# ADA Curb Ramp New Construction Inspection Form (Combination)

Nw 287

24952.54

Nw mays

COMBINATION RAMP (C)

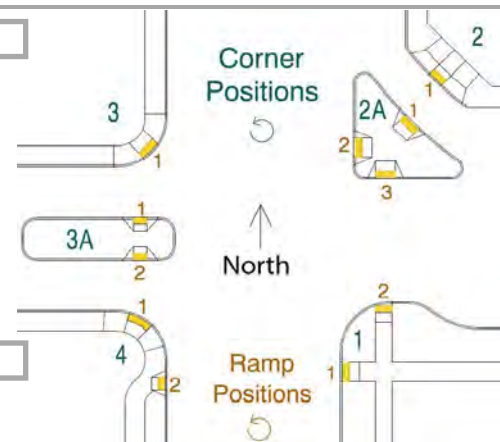
2.5

☒

IITD RR1 fail
